**Heritage Advisory Committee
January 22, 2014**

SUBJECT: **Case H00395: Substantial Alterations to 5171 George Street (Bank of Commerce building); 1813 Granville Street (Hayes Insurance building); 1819 Granville Street (Merchants Bank of Canada building); 1824 Hollis Street (Champlain building); and 1820 Hollis Street (Flinn building) – 5 municipally registered heritage properties**

Case H00395: Substantial Alteration to 5 Heritage Buildings

In association with 22 Commerce Square

Attachment D - South Elevation

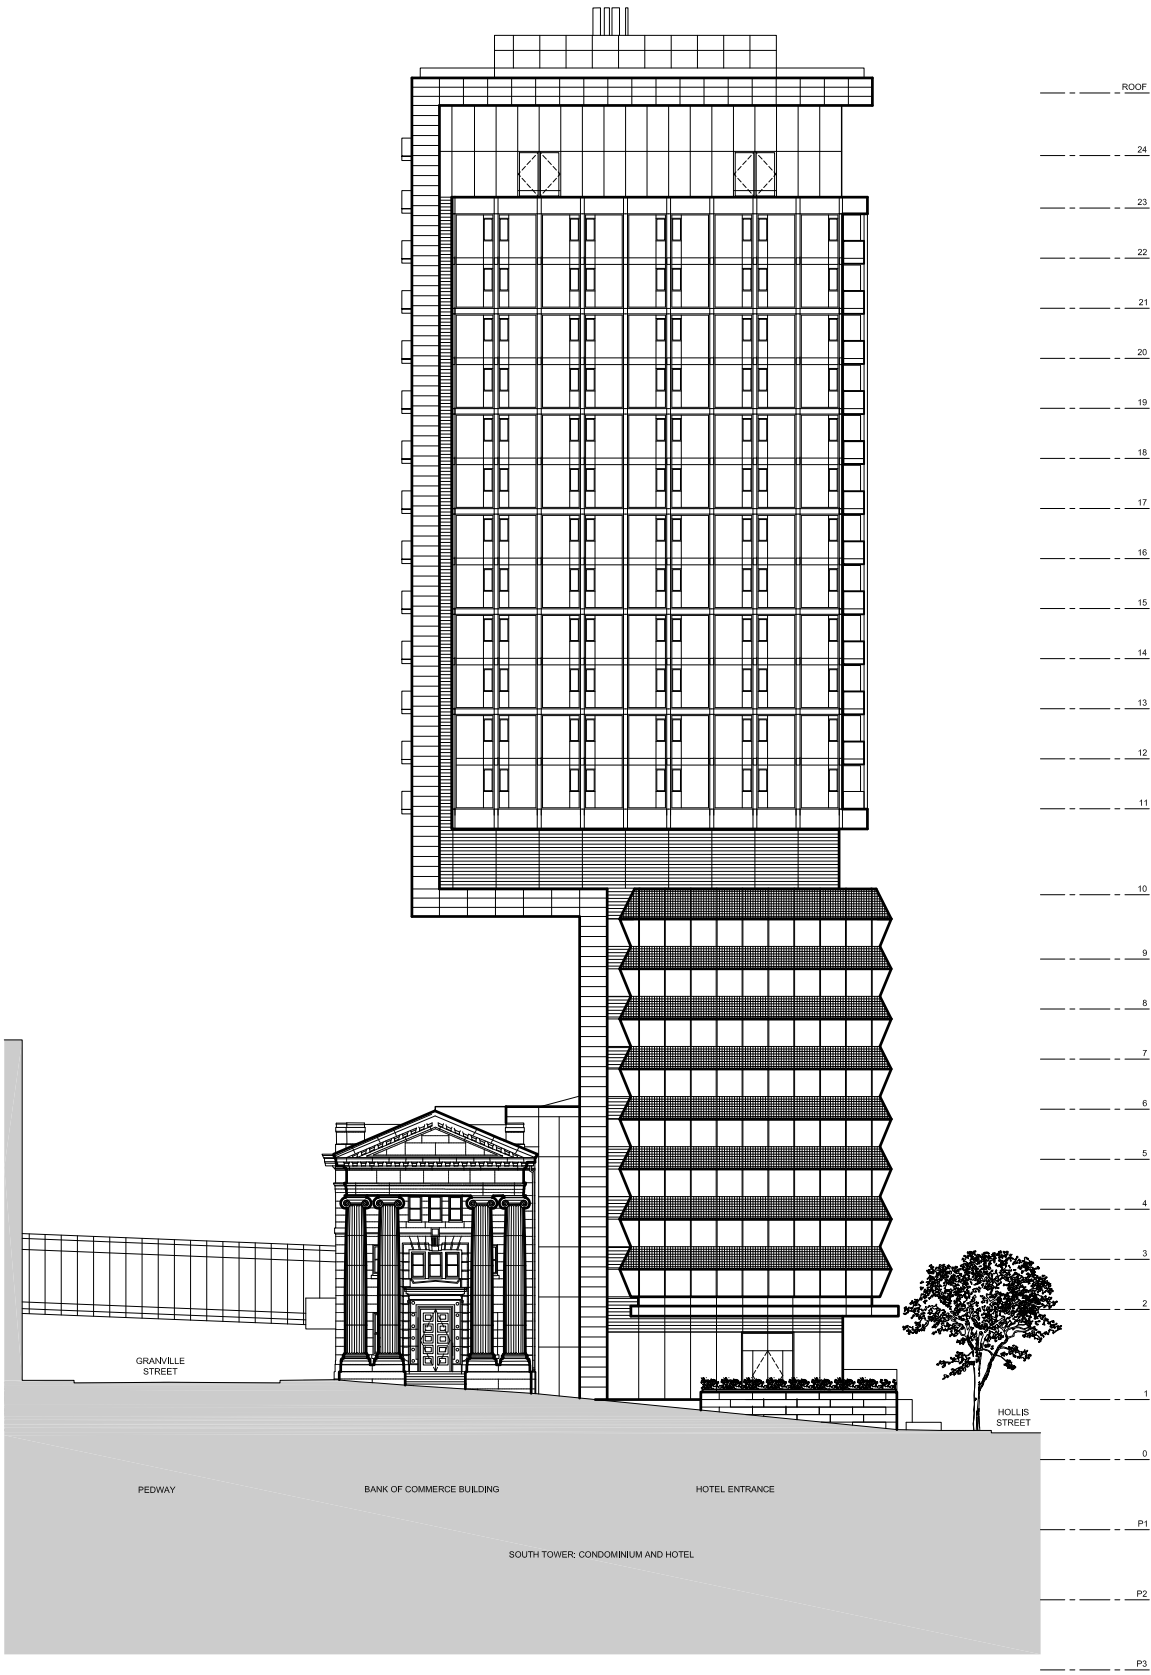
The design of the south tower base employs a cantilever of the tower over the Bank of Commerce building allowing it to remain intact (Attachment D). However, its rear addition will be reduced to a freestanding façade (Attachment A). The south tower is designed to create juxtaposition with the formal architecture of the Bank of Commerce building. It accomplishes this both in the ‘accordion’ design of the base, and the use of the cantilever.

1. Approve the proposed substantial alteration to 5171 George Street (Bank of Commerce building) as outlined in Attachments A-Y of this report, subject to the integration of the rear bank addition into the new development;
2. Approve the proposed substantial alteration to 1813 Granville Street (Hayes Insurance building) as outlined in Attachments A-Y of this report;
3. Approve the proposed substantial alteration to 1819 Granville Street (Merchants Bank of Canada building) as outlined in Attachments A-Y of this report;
4. Approve the proposed substantial alteration to 1824 Hollis Street (Champlain building) as outlined in Attachments A-Y of this report, subject to the reinstatement of the 5th and 6th floors; and
5. Approve the proposed substantial alteration to the 1820 Hollis Street (Flinn building) as outlined in Attachments A-Y of this report.
